**FINAL**  
**ENVIRONMENTAL IMPACT REPORT**

**LION'S GATE RESERVE**

**Lead Agency: County of Santa Clara**

**File #4039-67-28-93**  
**SCH #94043016**

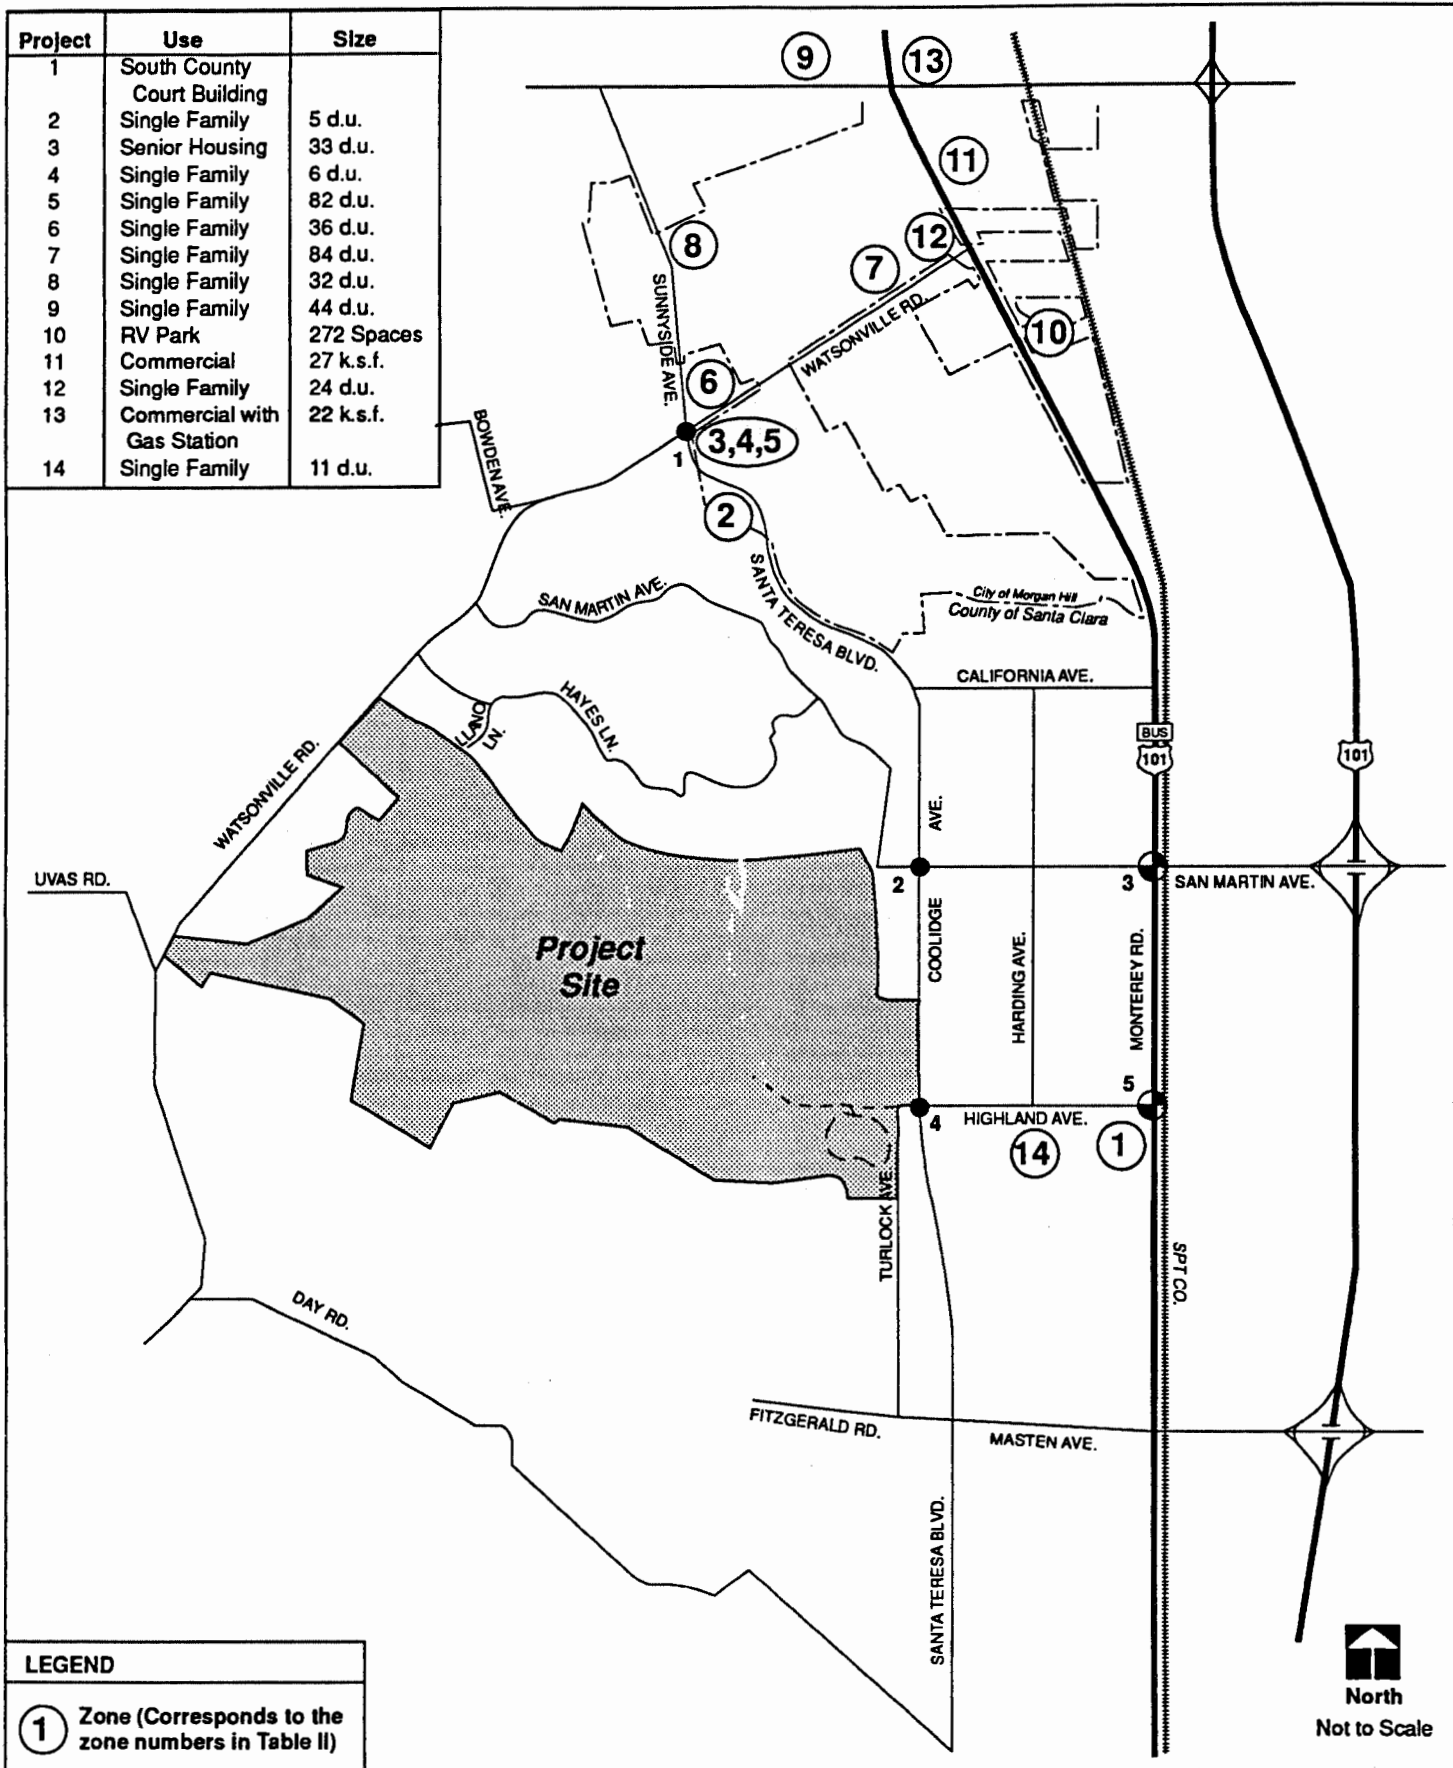
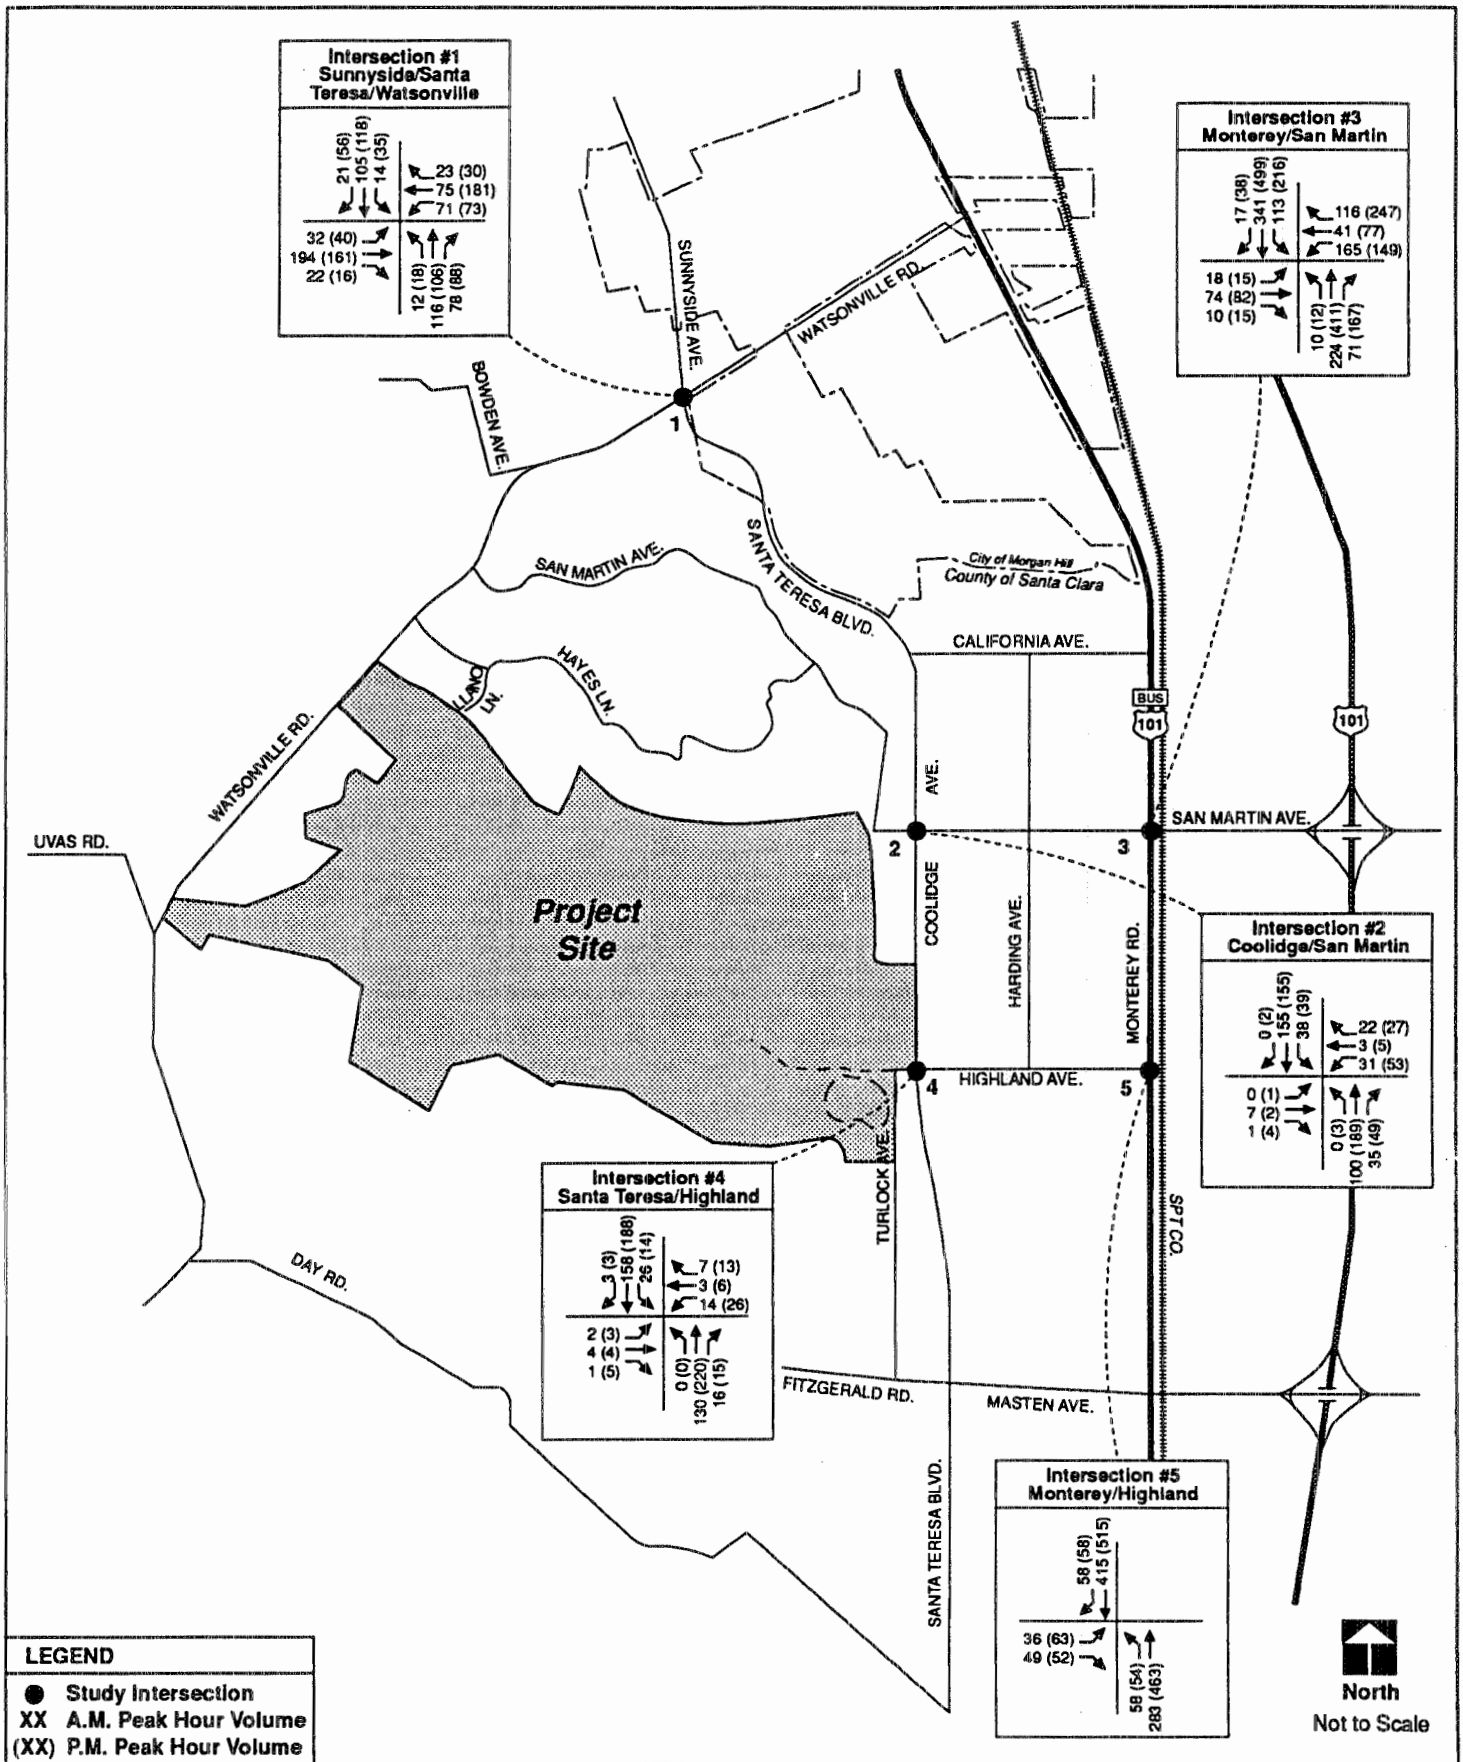
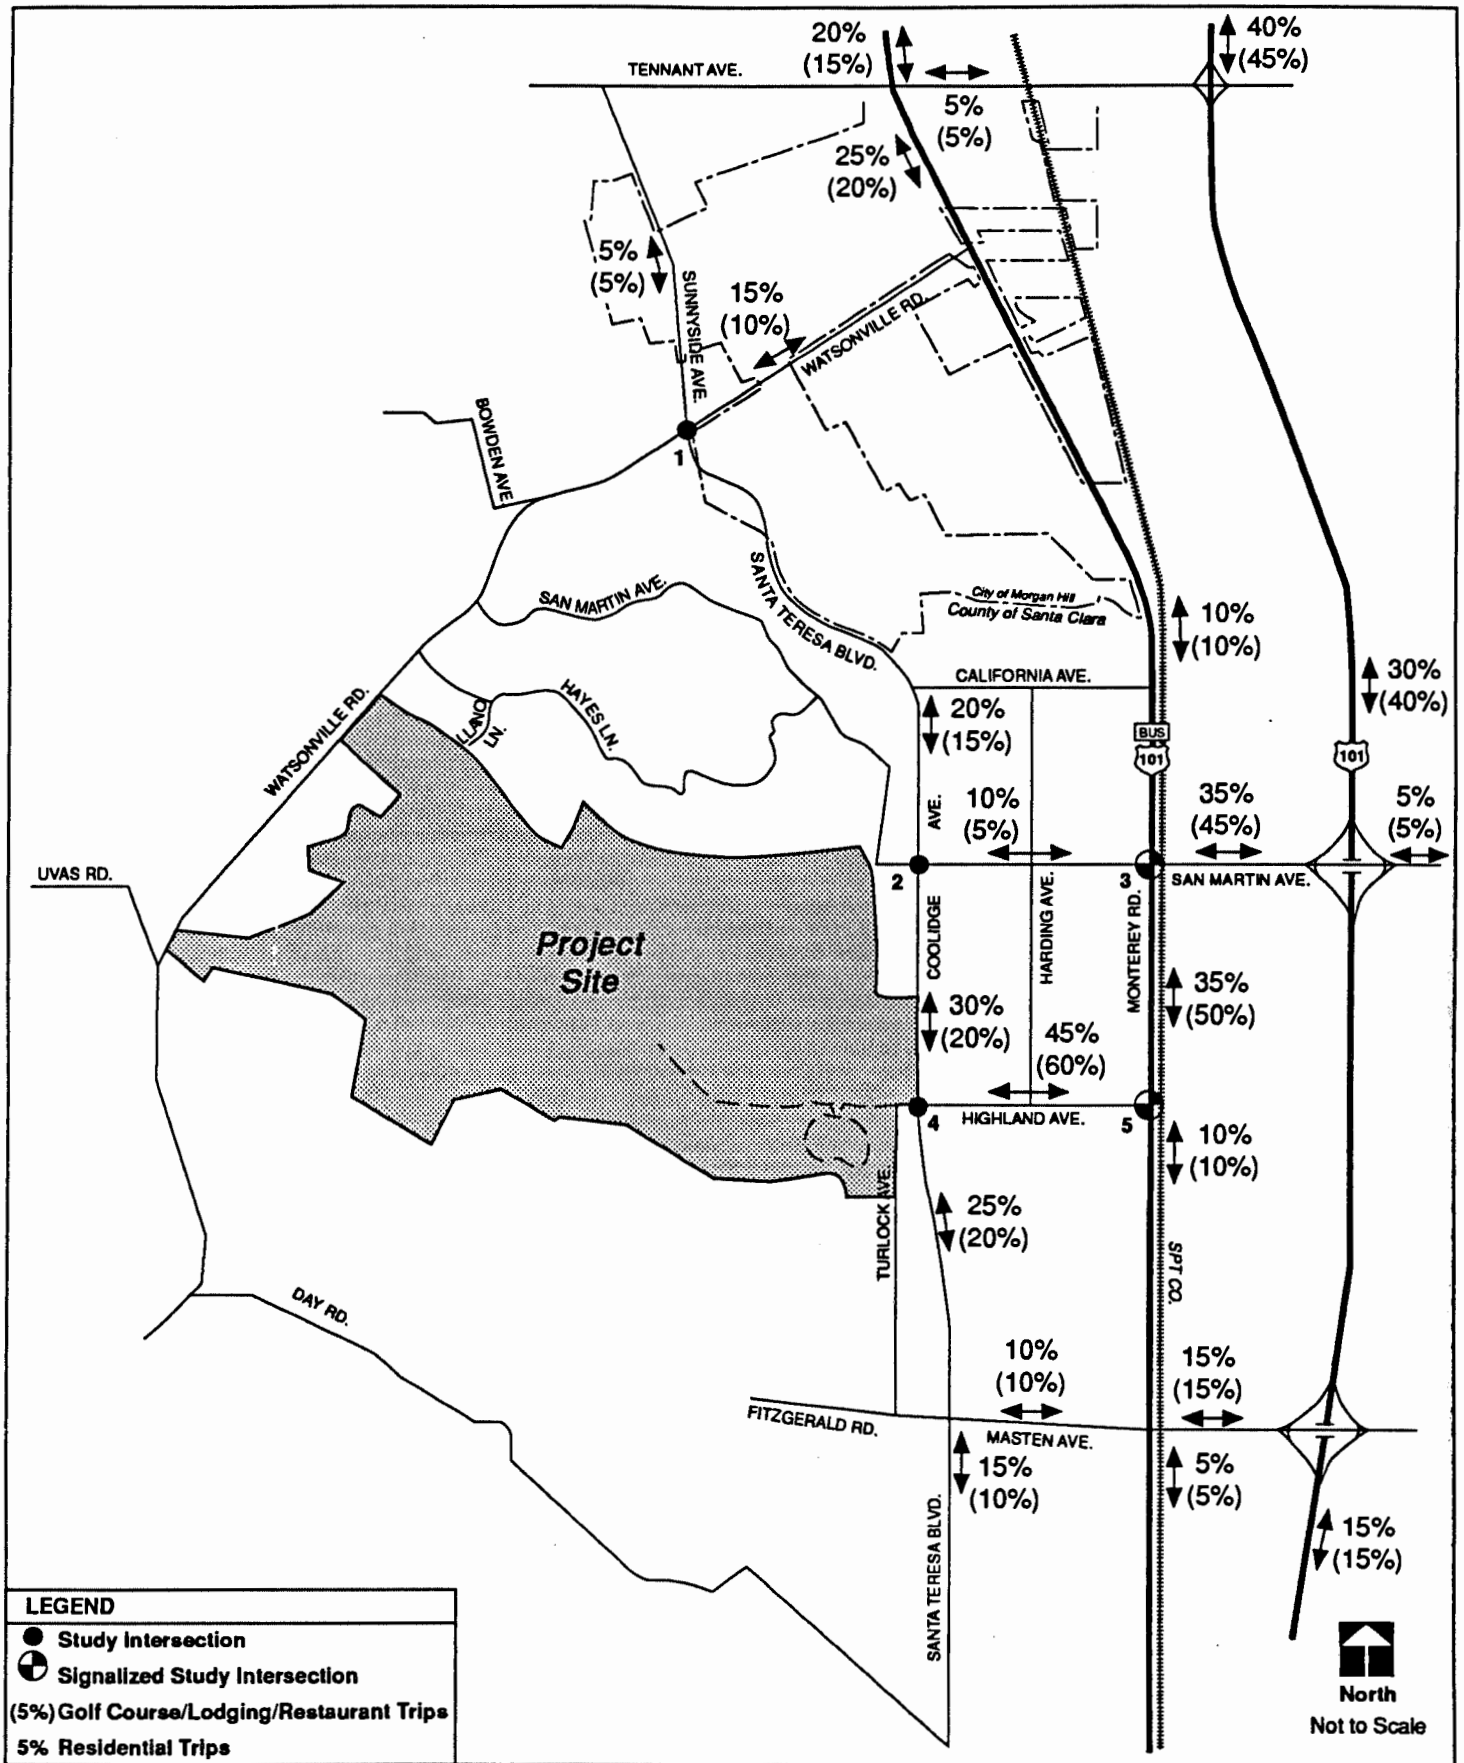
" Background Traffic-Existing Plus Approved Projects," last sentence refers to "a table of these approved projects and a figure...in Appendix G of this EIR." There is no such table in Appendix G, the Historical and Architectural Evaluation section. Could this be a reference to the "missing" Figure 3 in Appendix H?

- a. Figure 1: existing transit routes in vicinity of proposed project
- b. Figure 3: locations of approved projects near study area
- c. Figure 4: project turning movement volumes
- d. Figure 6: trip distribution assumptions
- e. Figure 7: projected study intersection turning movements for existing plus approved plus project
- f. Figure 8: forecasted turning movement volumes

Is it possible that some of the figures in Volume I of the DEIR, i.e., figures 18, 19, or 20, should have been the figures provided in items b, c, d, e above? Please clarify.

3. The reference to Appendix G should have read "Appendix H." The table listing the approved projects is identified as Table II of the traffic report in Appendix H. The EIR has been revised to include this corrected information. (See Section *V. TEXT AMENDMENTS*.)
4. Comment acknowledged. All but one of the figures prepared by TJKM for Appendix H were inadvertently omitted from DEIR Volume III. Several of these missing figures appear in Volume I of the DEIR as follows: the missing Figure 1 in Appendix H is the same as Figure 17 in the DEIR; Figure 2 is the same as Figure 18; Figure 4 is the same as Figure 19; Figure 6 is the same as Figure 20; and Figure 7 is the same as Figure 21 in the DEIR. Figures 3 and 8 are missing altogether. The EIR has been amended to include the figures missing from Appendix H. (See Section *V. TEXT AMENDMENTS*.)
